VIRGINIA ELECTRIC AND POWER COMPANY (DOMINION)
NORTH ANNA POWER STATION UNITS 1 AND 2
RESPONSE TO REQUEST FOR ADDITIONAL INFORMATION
LICENSE AMENDMENT REQUEST
MEASUREMENT UNCERTAINTY RECAPTURE POWER UPRATE

**RESPONSE TO REQUEST FOR ADDITIONAL INFORMATION
LICENSE AMENDMENT REQUEST
MEASUREMENT UNCERTAINTY RECAPTURE POWER UPRATE**

**VIRGINIA ELECTRIC AND POWER COMPANY (DOMINION)
NORTH ANNA POWER STATION UNITS 1 AND 2**

Feedwater Line Drawings

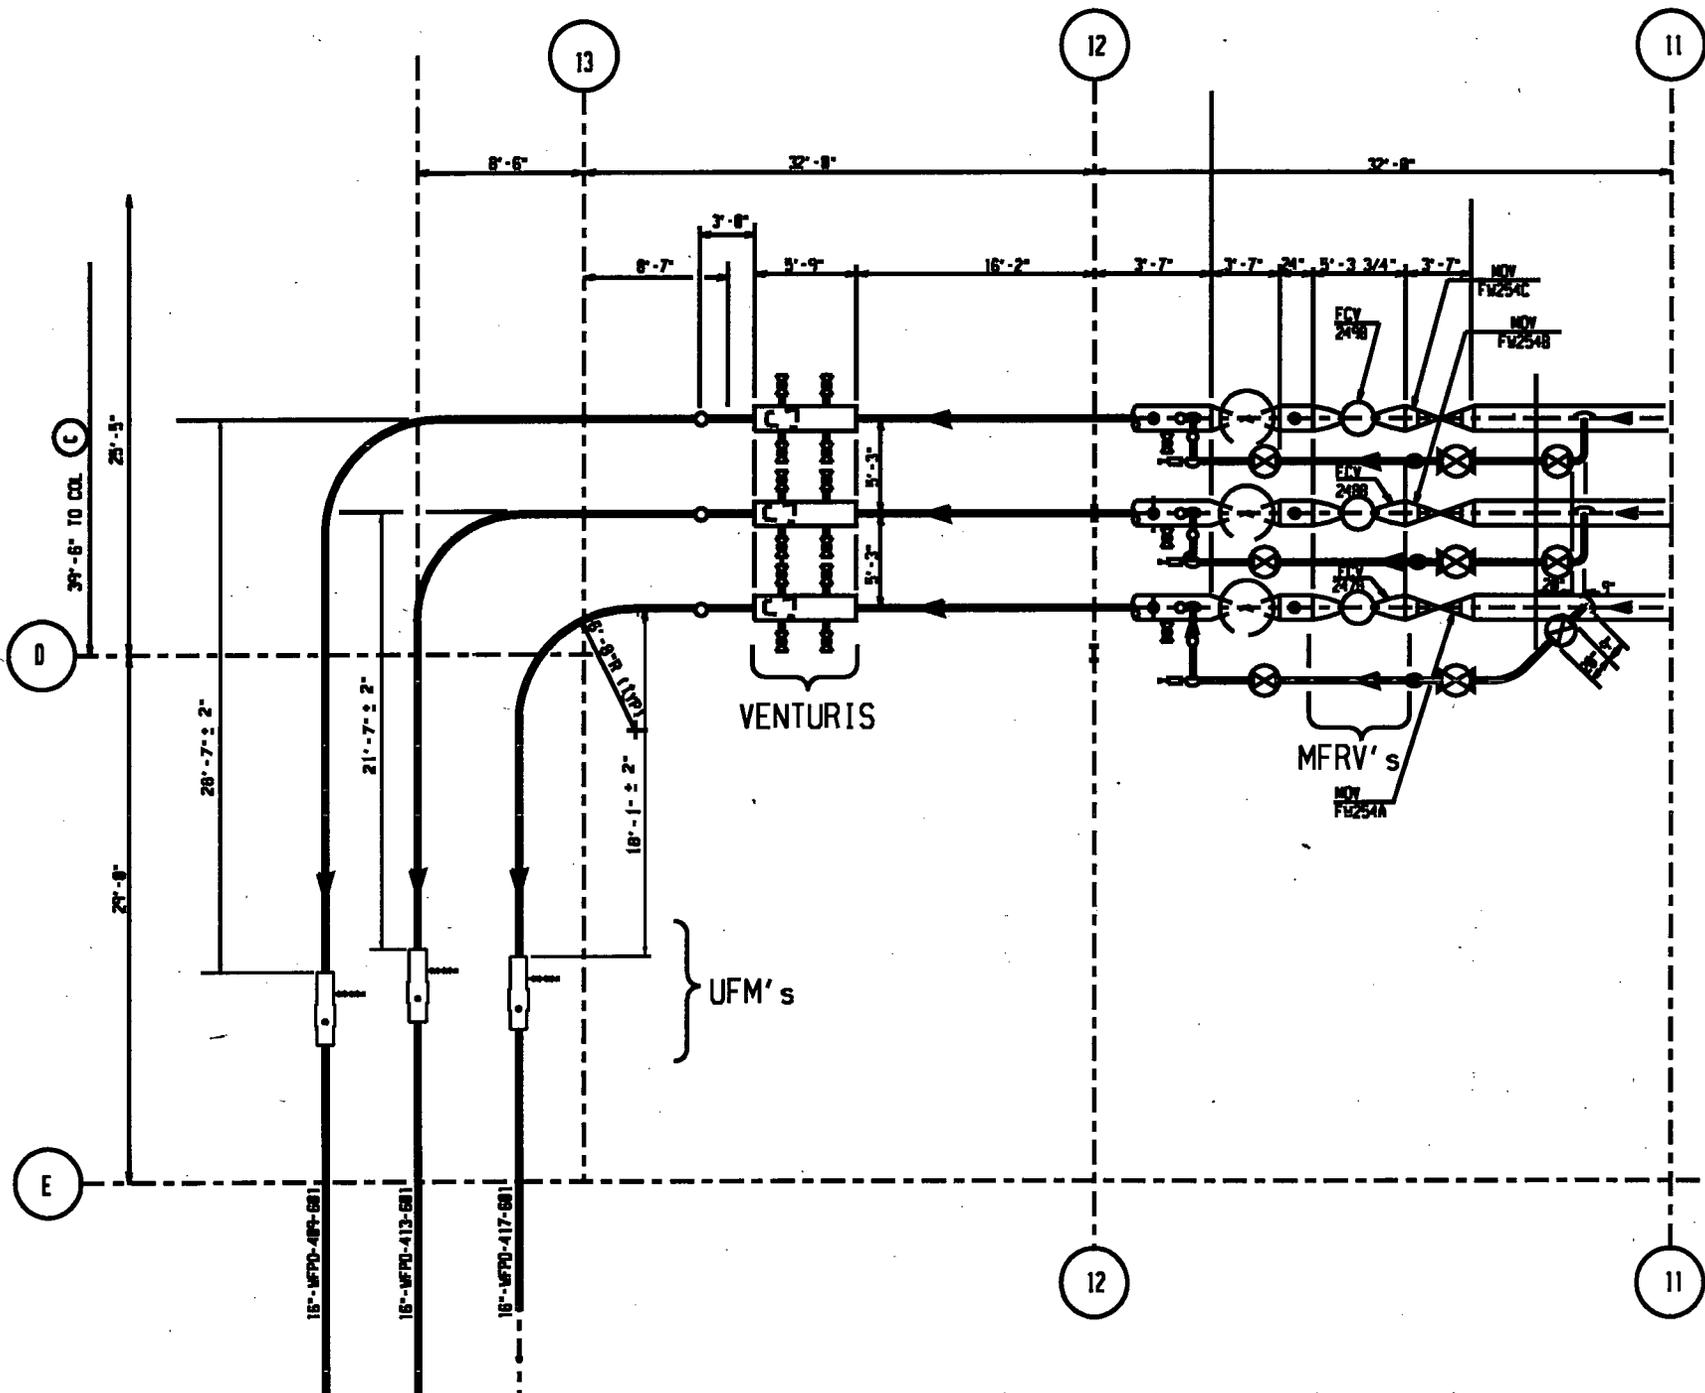
Describe and provide drawings of the location where the Ultrasonic Flow Meter (UFM) will be installed in the 3 main feedwater lines between the existing feedwater venturi flow meters and the main feedwater check valves.

The basic configuration for the feedwater (FW) lines in both North Anna Units 1 and 2 are similar. The lines contain, in sequence, the FW flow venturis, a 90 degree pipe bend, the UFM spool piece metering sections and finally the main FW check valves. The location of the UFM spool piece metering sections can be specified relative to the centerline of the upstream 90 degree bend. The following table provides the actual distance downstream from the upstream bend.

Unit	FW Line	Distance downstream of the centerline of the feedwater line upstream of the pipe bend
NAPS U1	A	29 feet 3 inches
NAPS U1	B	14 feet 1 inches
NAPS U1	C	24 feet 0 inches
NAPS U2	A	18 feet 1 inches
NAPS U2	B	21 feet 7 inches
NAPS U2	C	28 feet 7 inches

Drawings showing the details of the UFM location for Unit 1 and 2 are enclosed.
